UNITED STATES PATENT AND TRADEMARK OFFICE

APPLICATION NO.	FILING DATE	FIRST NAMED INVENTOR	ATTORNEY DOCKET NO.	CONFIRMATION NO.
10/015,701	12/17/2001	Kyeong Jin Kim	8733.479.00	6382

Office Action Summary

DETAILED ACTION

FIG. 3A

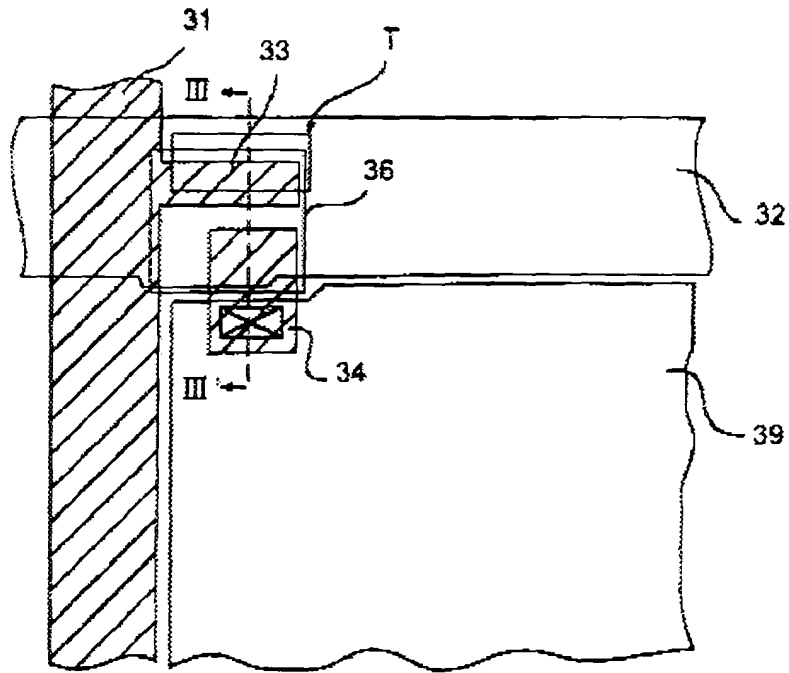
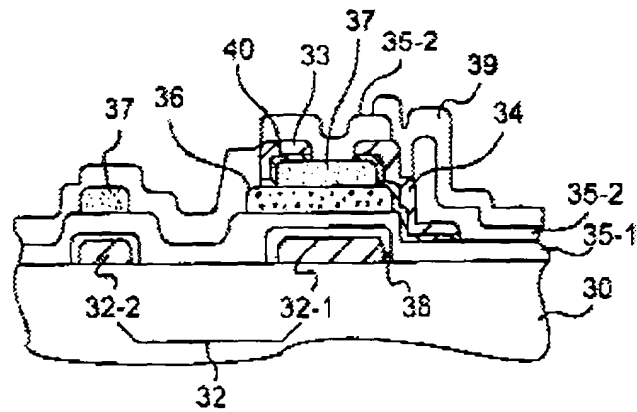
As to claims 1, 7, and 10, Ohe discloses (Abstract and entire patent) a method of forming a liquid crystal display device comprising: forming an L-shaped thin film transistor (Figure 3A, col. 6, lines 32-37) and a pixel electrode, 39, on a first substrate.

FIG. 5

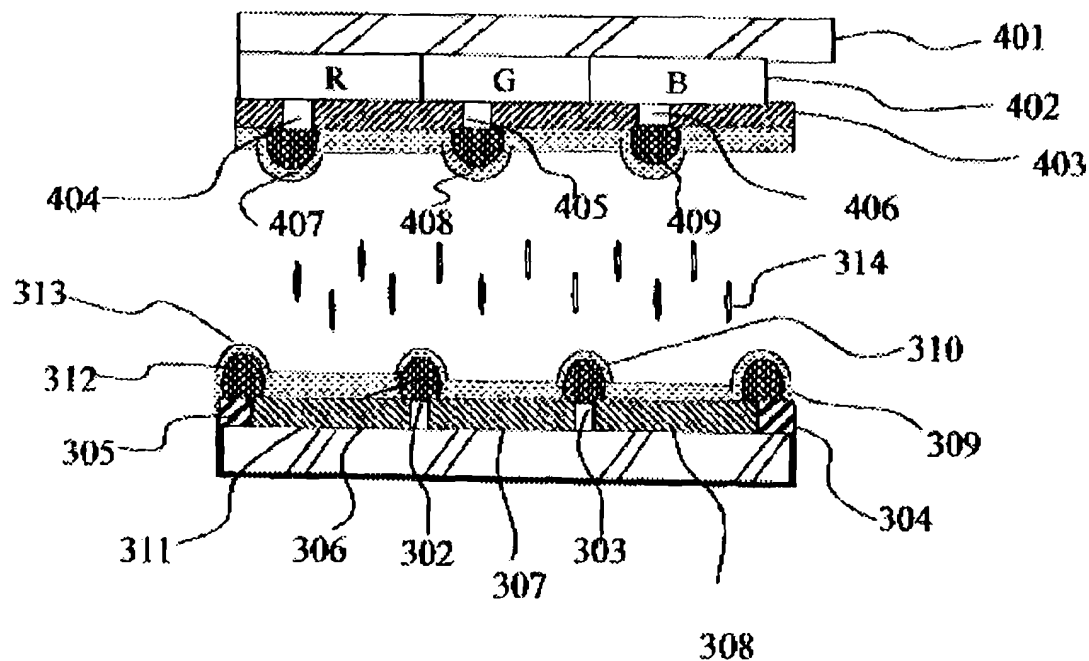
Liu teaches (Abstract and entire patent) forming bumps, 311 and 409 (Applicant's dielectric frame) on both substrates (Figure 5, col. 5, lines 45-57, and col. 5, lines 35-44) having a first height and a sealant having a second height (not shown) such that the sealant is taller than the dielectric frame as is evidenced by the gap between the dielectric frames and the opposed substrate (Figure 5) to comprise a multi-domain display with wide viewing angle (col. 2, lines 36-46).

As to claim 13, Liu, as combined above, teaches a method wherein the dielectric frame, 409, is formed on the common electrode, 403 (Figure 5).

As to claim 14, Liu, as combined above, teaches a method further comprising forming an alignment layer, 313 and 407, on the first and second substrates (Figure 5).

FIG.3

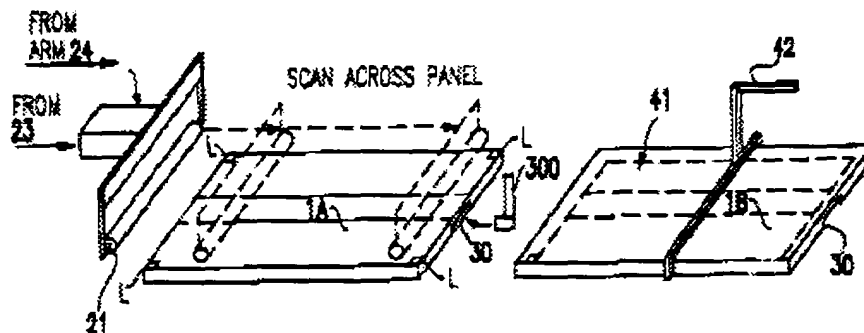
Von Gutfeld teaches dispensing liquid crystal on the first substrate (Abstract and entire patent); and attaching the first and second substrates to each other to provide a simplified and more efficient method for filling an unassembled LCD panel that is less costly (col. 2, lines 25-34).

As to claim 3, Von Gutfeld, as combined above, teaches that the sealant includes a double sealant structure in that there is a seal on the right and a seal on the left. Von Gutfeld teaches that the sealant includes a double sealant structure in that there is a seal on the top and a seal on the bottom. Also, please note that mere duplication of the essential working parts of a device involves only routine skill in the art. For example additional redundant seal borders inside or outside a first seal would be considered mere duplication of parts, not a patentably distinct species, unless unexpected results were obtained.

FIG. 2

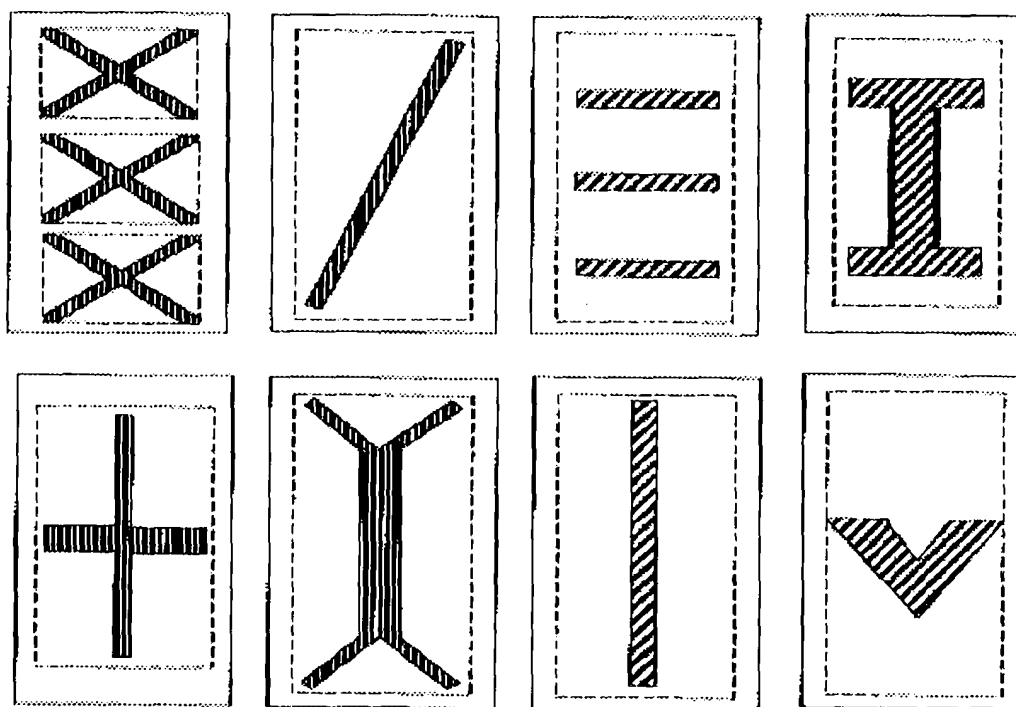
As to claim 5, Liu, as combined above, teaches in Figure 2 a method wherein the electric field inducing window has a slit shape or a hole shape.

FIG. 1 (Prior Art)

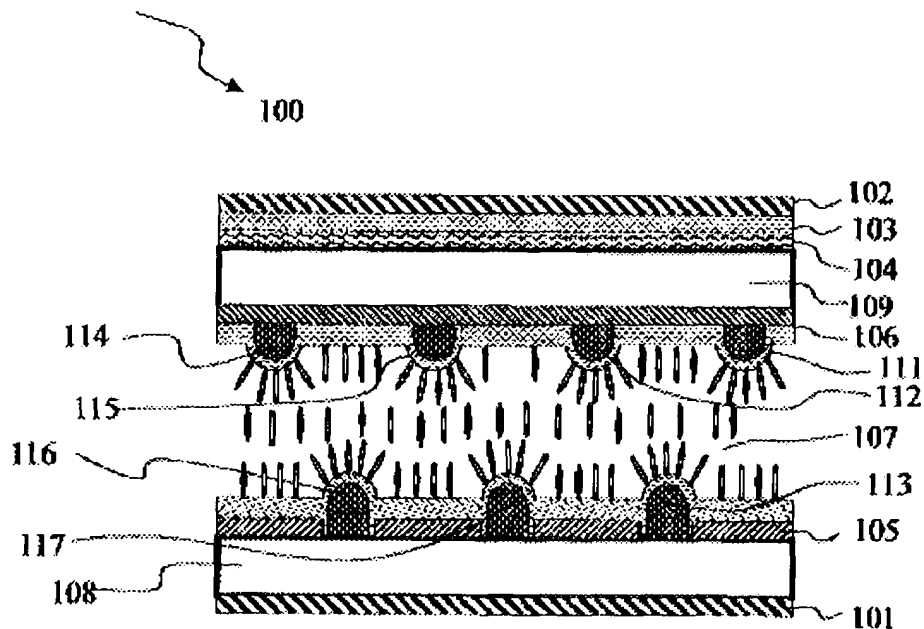
As to claim 9, Liu, as combined above, teaches Prior Art in Figure 1 that shows dielectric frames drive the liquid crystal in various directions.
